REPORT ON THE FAILURE
OF THE
EMPRESS DOCK NORTH WALL
BY
J. Wolfe Barry.
1888,

SOUTHAMPTON DOCKS.

DEEP WATER DOCK.

SECTION OF NORTH WALL.
Scale 1 in = 12 ft.

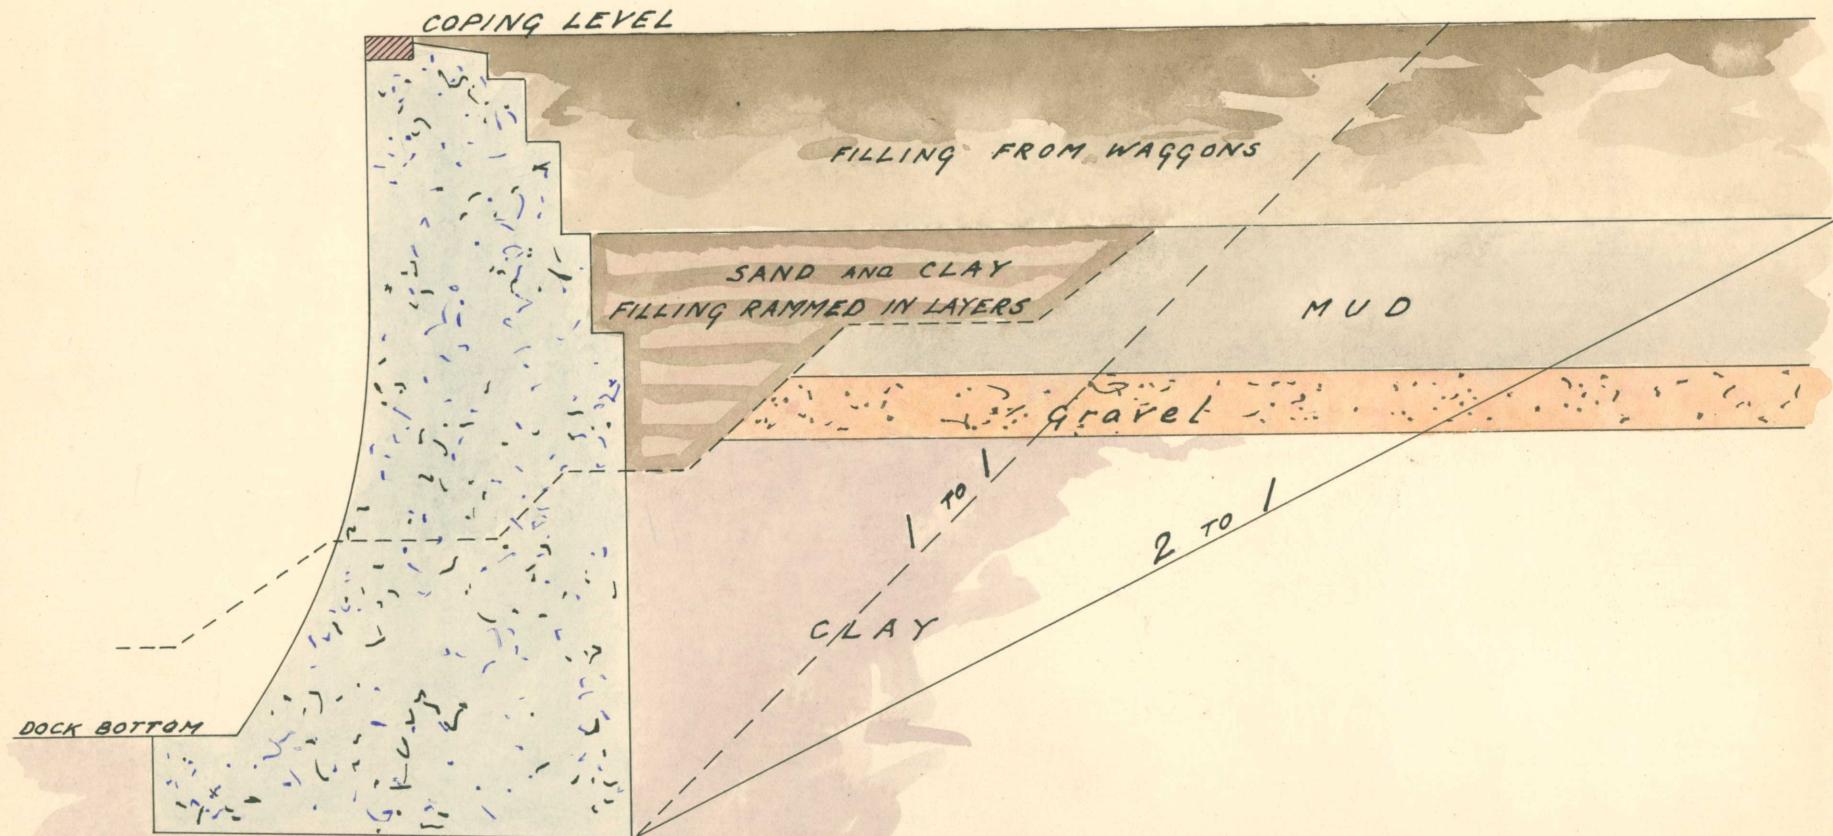
up to coping level or thereabouts and the wall gave way about a week afterwards. The above description of the wall and backing which is I believe at least approximately correct, will be better understood from the accompanying cross section.

that allowing for the sloping back of the clay and the removal of the mud, the slope of the ground behind the wall from the base of the wall to the top of the rammed filling was approximately 1 to 1 and that above the mud there was a height of about 13 feet of backing resting on a bed of mud.

I consider that ground such as I have described would not stand at such a slope as 1 to 1 but would more probably require a slope of 2 to 1 for stability. The ground behind the wall would thus give rise to very considerable horizontal pressure which would be much in excess of that produced by ground and backing such as is ordinarily

To sum up therefore, my reply to your first question is, that the cause of the misfortune was, in my opinion, the existance close behind the wall of the mud and clay, and of the presence of water in the gravelly bed, coupled with the fact that the backing, rammed in layers, had so much clay mixed with it, that water could not readily find access to the pipes which had been provided through the wall for the purpose of relief.

in rebuilding the wall are, in my opinion to carry its foundations considerably deeper into ground undisturbed by the movement which has taken place and to remove the clay and mud to a much greater distance behind the wall, replacing them with more and better backing, which should rest on horizontal beds. In addition to this, all soaks and drains of water from the gravel should be led through the backing to the drain pipes through the wall so as to avoid as far as possible any action of the water on the Clay beds.

I think that the steps which should be
taken at the present time in respect of the
other walls are in the direction of diminishing
the pressure behind the walls by using a greater
width of backing, resting on horizontal beds,
and in improving its quality, keeping at all
times a free exit through the wall for any water
which may accumulate in the gravel beds.
